OMF 63					0118.2143	
creation date	created by	release date	released by	notification no.	revision	page
2012-11-29	elmigeth	2012-12-21	elmigeth	24238	a	1 of 2

New halogen-free thermoplastic material for fuse housing

old thermoplastic material	new thermoplastic material

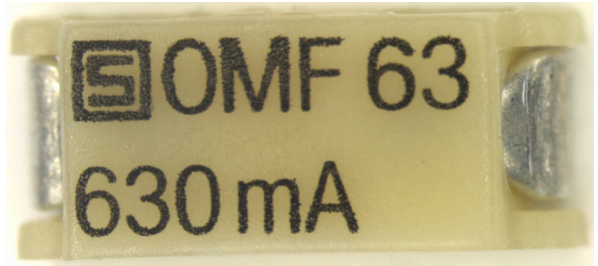
The material of the fuse housing changes from normal thermoplastic material to a halogen-free thermoplastic material. There is no influence on form-fit-function of the OMF 63, with the exception of a slightly different color shade (see photos below). Fuses with the old thermoplastic material can still be used.

Form:	Yes	Change of the color shade only
Fit:	No	
Function:	No	
Production Site:	No	
Product Label:	No
